UNITED STATES PATENT AND TRADEMARK OFFICE

APPLICATION NO.	FILING DATE	FIRST NAMED INVENTOR	ATTORNEY DOCKET NO.	CONFIRMATION NO.
10/662,053	09/12/2003	D. Clark Turner	21173.NP	8330

Office Action Summary

Figure 5-Coated Transmission Window-U.S. Patent 5,226,067 to Allred et al.

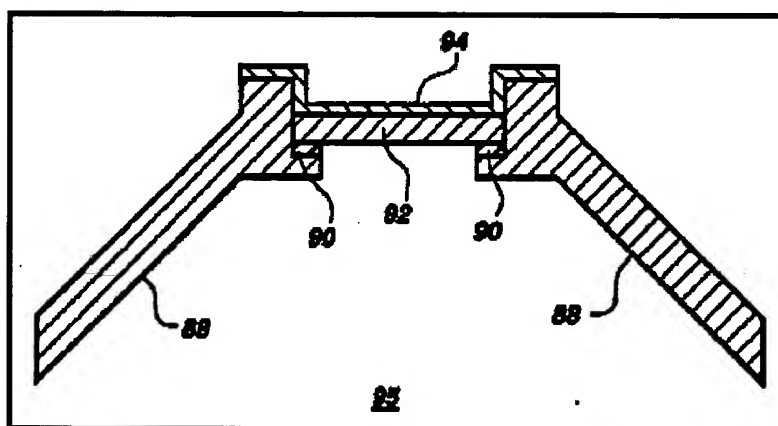
6. As per claim 1, Allred et al. discloses a window device comprising: a) a support (88), b) a film (92), c) an adhesive (90), d) a coating (94); wherein the film, adhesive and coating form a vacuum tight assembly (column 3, lines 39-46) and capable of withstanding a temperature greater than approximately 250 degrees Celsius (Fig. 11, not shown above; column 6, lines 13-32; column 8, lines 36-41).

7. **As per claim 2**, Allred et al. discloses a window device wherein the film (92) is directly adhered to the support without any stress relief structure (Fig. 1 above).
8. **As per claims 3 and 4**, Allred et al. discloses a window device wherein the coating (94) also covers an exposed portion of adhesive and covers both evacuated and ambient sides of the film (Fig. 1 above; Fig. 11, not shown above; column 6, lines 13-32; column 8, lines 36-41).
9. **As per claim 6**, Allred et al. discloses a window device wherein the film (92 - Beryllium) includes a native oxide covering that is covered by the coating (94) (see Fig. 1 above).
10. **As per claim 11**, Allred et al. discloses a window device wherein the support forms part of a sealed evacuated chamber, and further comprising an X-ray detector or an X-ray source (column 1, lines 5-22; see also respective Figs., not shown above).
